REMEDIATION SYSTEM EVALUATION (RSE)

NORTHWEST PIPE AND CASING SITE CLACKAMAS, OREGON

Report of the Remediation System Evaluation
Site Visit Conducted May 9, 2007

Final Report
September 2007

Figure 1-2. Water Levels in Shallow Water Bearing Zone

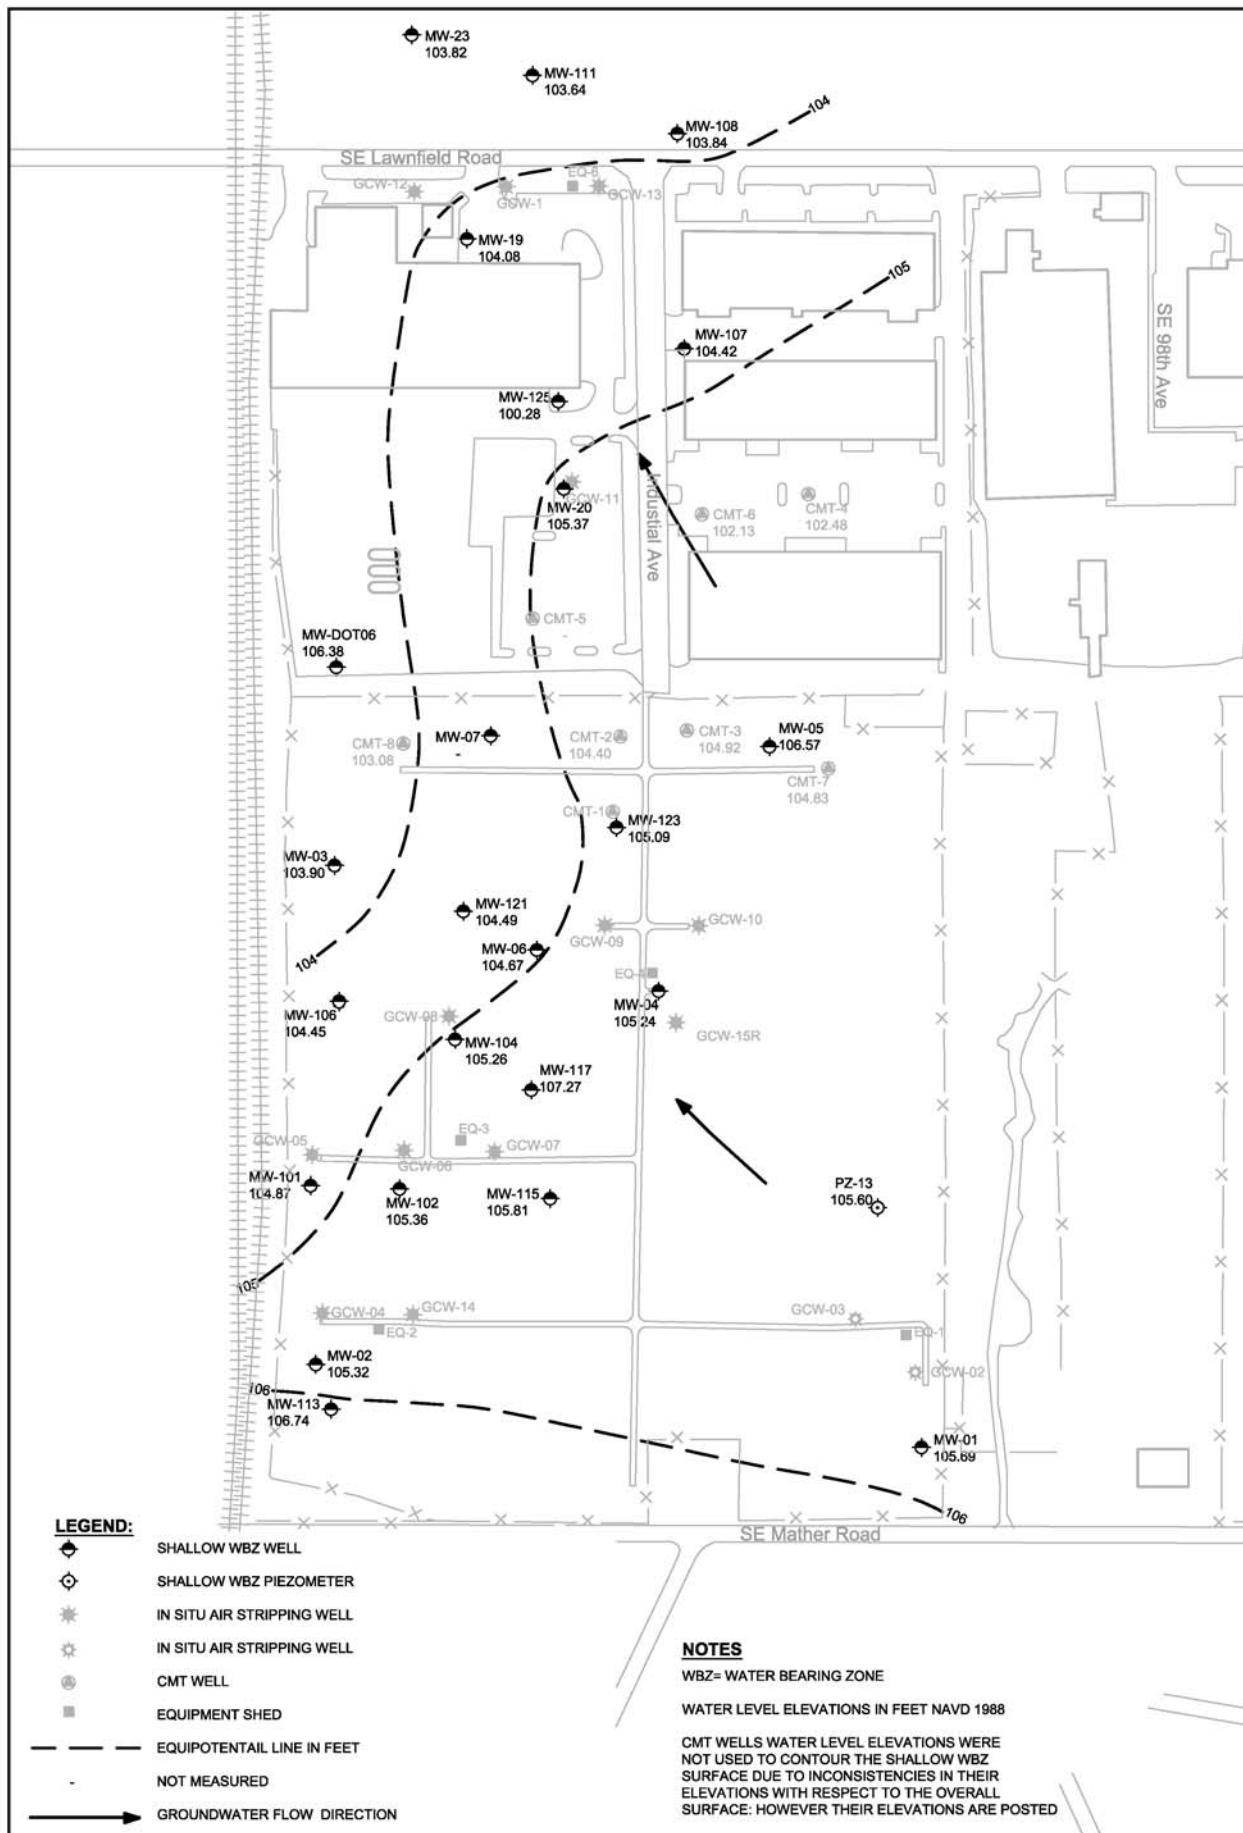
The RSE team notes that the water level maps presented in Figures 1-2 and 1-3 do not indicate any substantial hydraulic impact from the GCWs. Water is extracted from the shallow screen and recirculated to the deep screen, but there are no obvious cones of depression in the Shallow WBZ, and no apparent mounding in the Intermediate WBZ, in the vicinity of the GCWs.

Figure 1-4. Total Concentration of PCE, TCE, and VC in Shallow Water Bearing Zone

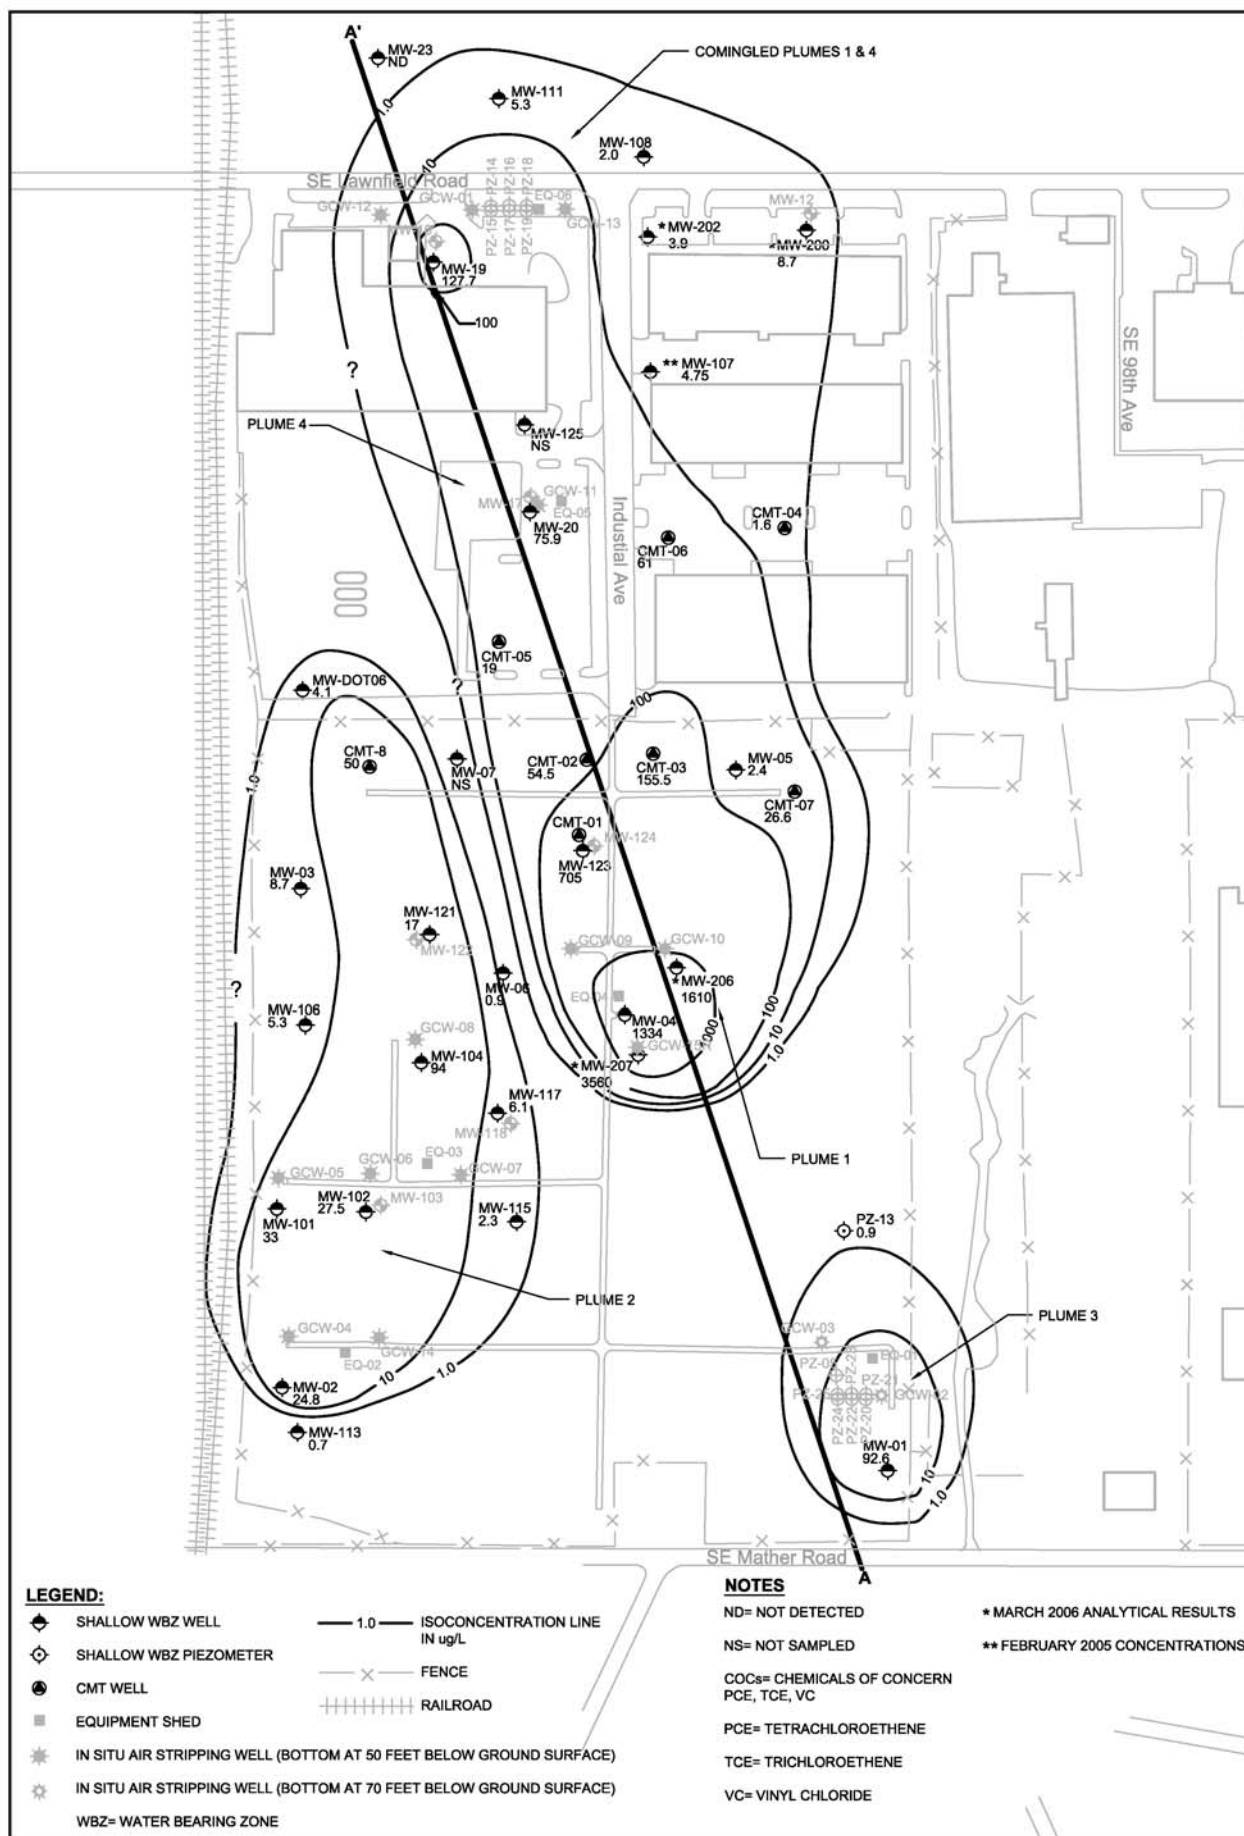
Inspection of Figure 1-4 indicates that the highest Total COC concentrations (i.e., greater than 1,000 ug/l) are observed in the Shallow WBZ at MW-04, MW-206, and MW-207. However, there are no permanent monitoring points located immediately south of these wells, and therefore the extent of this “core area” of higher concentrations cannot be easily determined. This is important because consideration of more aggressive measures for reductions of the highest concentrations at the site (such as chemical oxidation or enhanced in-situ bioremediation) has been suggested by Parametrix, and is also recommended by the RSE team (see Section 6.4). The implementation and cost of these more aggressive approaches will depend on the size of the “core area” of highest concentrations. Therefore, unless the site team has information from other previous direct-push investigations that clarifies the delineation in this area, the RSE team recommends that an investigation be performed in the area south of the three wells listed above, in the Shallow WBZ, using direct push techniques or temporary wells installed with rotosonic drilling. It was stated during the RSE site visit that direct push techniques can be problematic at this site due to angular gravels, and the RSE team defers to the site team to select the appropriate technology. Assuming a brief work plan, up to two days of drilling work in the Shallow WBZ, analysis of up to 10 samples for VOCs, and a brief report summarizing results, a cost of approximately \$30,000 is estimated.
